Location: 211 Wickham Road, Croydon CR0 8TG

Appeal Ref: APP/L5240/W/23/3318858

LPA Application Ref: 23/00231/FUL

Proposal: Demolition of existing structures to the rear of 211 Wickham Road and erection of a two-storey building containing four dwellings (1 x 3 bed and 3 x 1 bed flats) with associated parking and refuse storage.

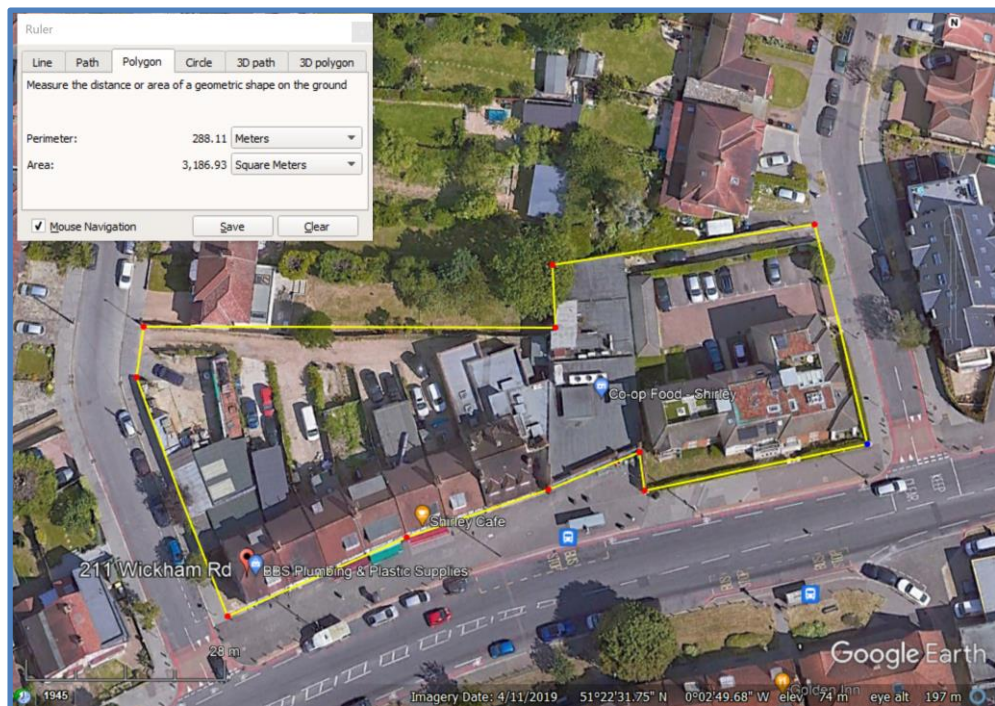
- 4.3.3.2 In response to **Item g)**: The access to the Bin Store at only **1.25m** wide. On collection days operatives of the Refuse vehicle will need to remove all bins for emptying into the refuse vehicle and the limited access will result in some congestion of this activity.

- 4.3.3.3 In response to **Item h)**: After re-evaluation we have re-assessed the access to the proposed cycle store at **1.25m** width past the refuse bins. However, to access a cycle in the furthest bay with all other bays occupied would be virtually impossible as the existing stored cycles significantly reduce access to within **≈60 to 70cm** width. To extract the furthest stored cycle physically from its bay and carry or wheel it out of the stored space would be a major task without possible injury.

**Graphical illustration of Post Code & Application Housing Density (Units/ha) & Residential Density (bedspaces/ha) Design codes.**

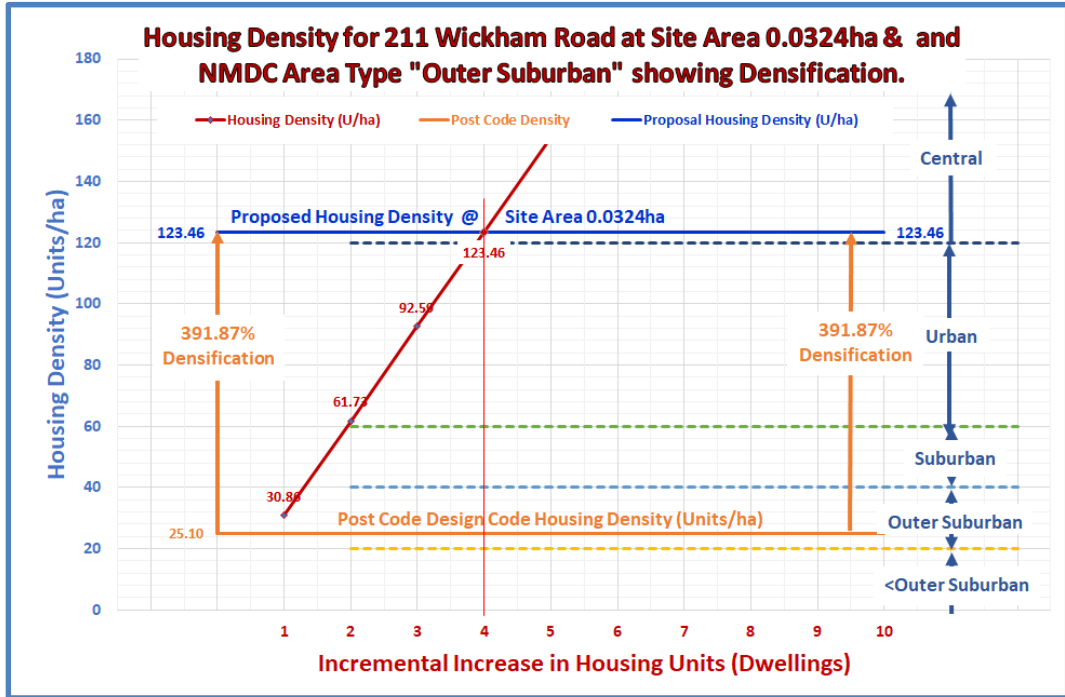
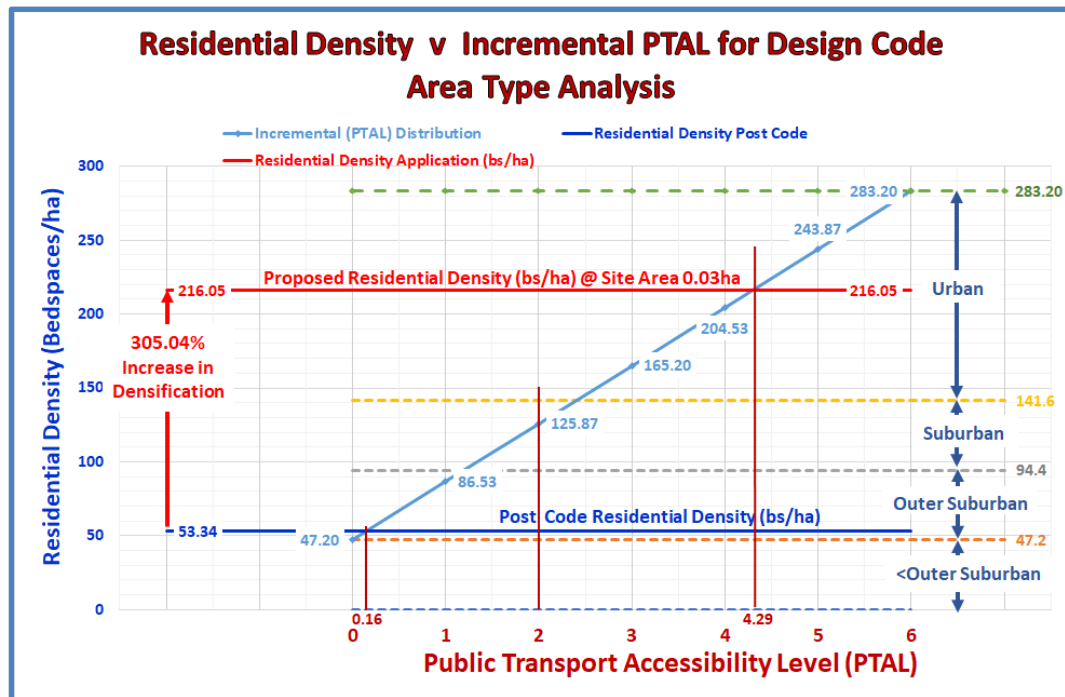
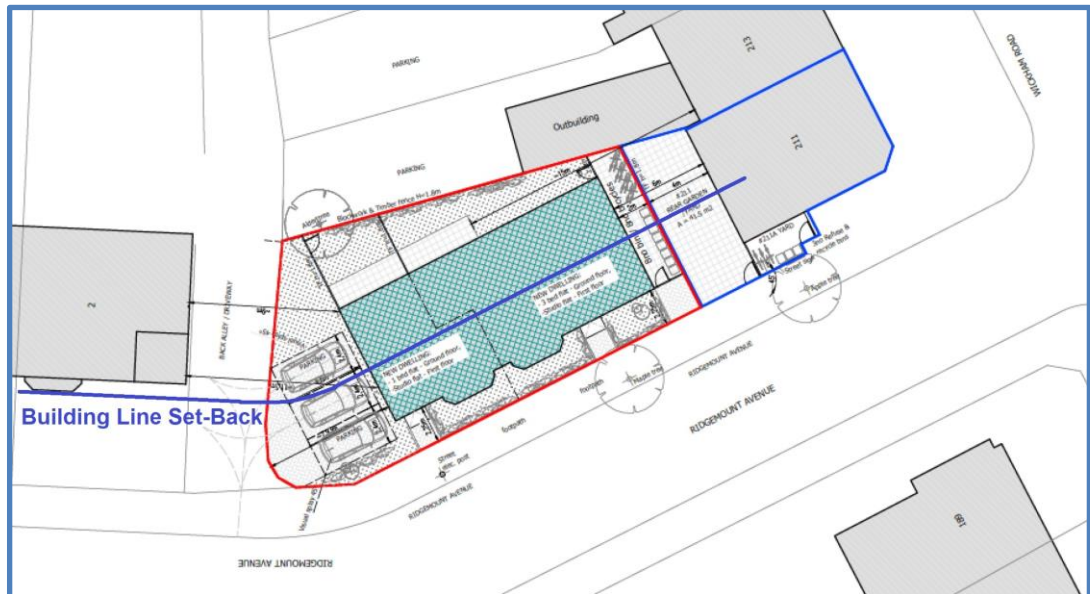
- 5.1.9 The **Housing Density** for the locality at **25.10u/ha** places the **Post Code** in an **Outer Suburban Area Type** Setting whereas the Application at a **Housing Density** of the proposed application would have a **Housing Density** of **123.46/ha** which is an increase of **391.87%**. This increase in **Housing Density** cannot be considered as appropriate for an evolutionary increase for redevelopment within an existing **Outer Suburban Area Type** Setting as defined by the **National Model Design Code and Guidance**.

- 5.1.10 Equally, the **Residential Density** of the Post Code locality is **53.34bedspaces/ha** which again places the locality in an **Outer Suburban Area Type** Setting whereas the Application would have a **Residential Density** of **216.05bedspaces/ha** which is an increase of **305.04%**. This increase in **Residential Density** would require an appropriate commensurate increase in **supporting infrastructure** and a comparable increase in accessibility to **Public Transport**. The equivalent value for **PTAL** would be a **PTAL of 4.29** when the available **PTAL** for the locality is **PTAL 2**.

- 5.1.11 We therefore have conclusively demonstrated the overdevelopment of the proposal for the locality as defined by the **National Model Design Code & Guidance** when assessed against the **Local Post Code** parameter **Design Codes** as compared to the **proposal's Design Codes**.

**The proposal does NOT follow the Building Line Set-Back of Ridgemount Avenue**

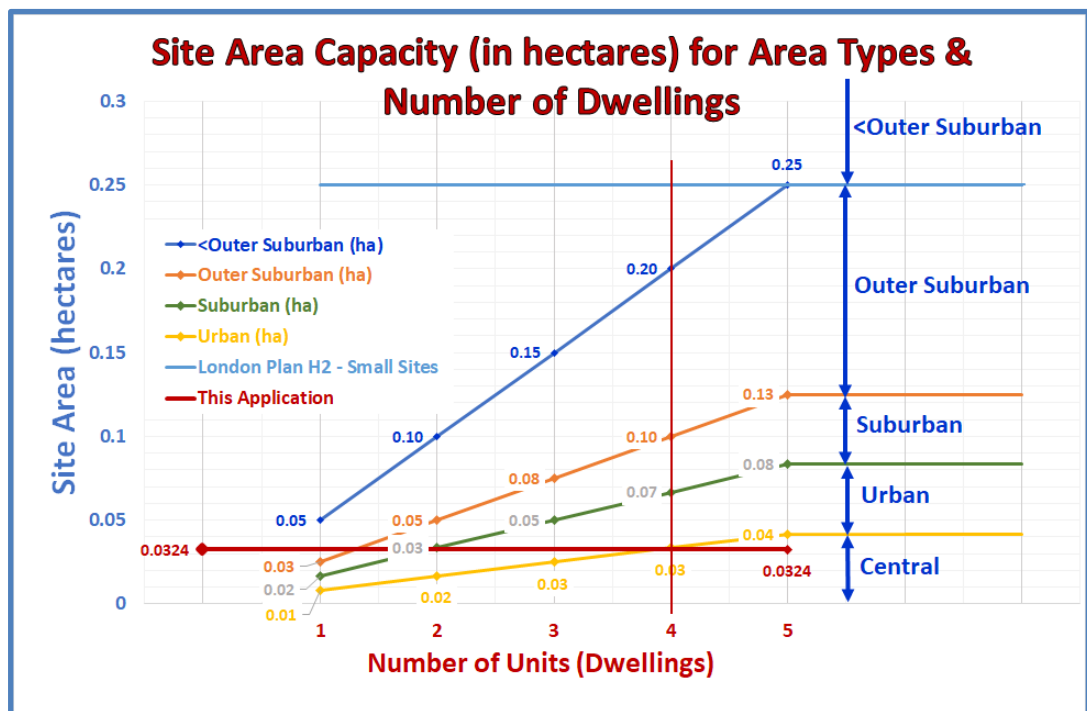
The proposal does NOT follow the established **Building Line Set-Back** along **Ridgemount Avenue** which contributes to the reasons for refusal and **Dismissal of this Appeal**.
